Access Compliance Report

Public Rights-of-Way

(Curb Ramps)

Intersection ID: 9455	Main Street: CAMBRIDGE_COMMONS_DR	Cross Street: SAM_DEE_RD	Location: E
ADA ID: 0C3C45DFC4FE	Ramp Type: BlendTrans1	Initial Pass/Fail: Fail	Overall Compliance: No
Severity Score: 21.25			
Codes/Mitigation Info/Possible Solution		Field Measurements/Component Compliance

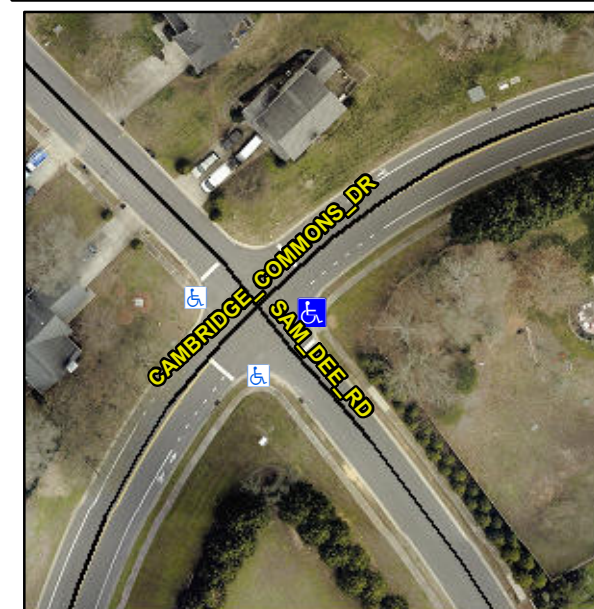
Not Found, R304.5.1, R304.5.3

Compliance	Description	Data	Compliance	Description	Data
N/A	Ramp Length (in)	35.0	Yes	BlendTrans Slope (%)	0.5
No	Ramp Width (in)	41.0	No	BlendTrans XSlope (%)	6.9
N/A	Flare Type LT	N/A	N/A	Flare Type RT	N/A
N/A	Flare Slope LT (%)	N/A	N/A	Flare Slope RT (%)	N/A
N/A	Flare Traversable LT?	N/A	N/A	Flare Traversable RT?	N/A
N/A	Landing Length (in)	N/A	N/A	DWS Provided?	N/A
N/A	Landing Width (in)	N/A	N/A	DWS Contrast?	N/A
N/A	Landing Slope (%)	N/A	N/A	DWS Length (in)	N/A
N/A	Landing X Slope (%)	N/A	N/A	DWS Full Width?	N/A
N/A	Landing Curb? (Y/N)	N/A	N/A	DWS Offset (in)	N/A
N/A	Shared Landing?	N/A			
N/A	Gutter Ponding?	N/A	N/A	Gutter Slope (%)	N/A
N/A	Gutter Lip Ht (in)	N/A	N/A	Gutter X Slope (%)	N/A
N/A	Painted X Walk1?	No	N/A	Painted X Walk2?	N/A
	X Walk 1 Direction	To SW		X Walk 2 Direction	N/A
	X Walk 1 Width (in)	N/A		X Walk 2 Width (in)	N/A
	X Walk 1 Slope (%)	3.8		X Walk 2 Slope (%)	N/A
	X Walk 1 X Slope (%)	4.6		X Walk 2 X Slope (%)	N/A

N/A	Ramp inside XWalk1?	N/A	N/A	Ramp inside XWalk2?	N/A
	Road Slope (%)	4.6		Clear Space?	N/A
	Road X Slope (%)	3.8	N/A	Clear Space to XWalk (in)	N/A
N/A	Any Obstructions?	N/A	N/A	Storm Grate/Utility Hazard?	N/A
	Obstruction Type			Storm Grate/Utility Type	
		N/A			N/A
			Yes	Surface Condition? (G/P)	Good
			No	Curb Slope (%)	18.2

Remove & Replace Curb Ramp With Two New Directional Ramps or Equivalent.
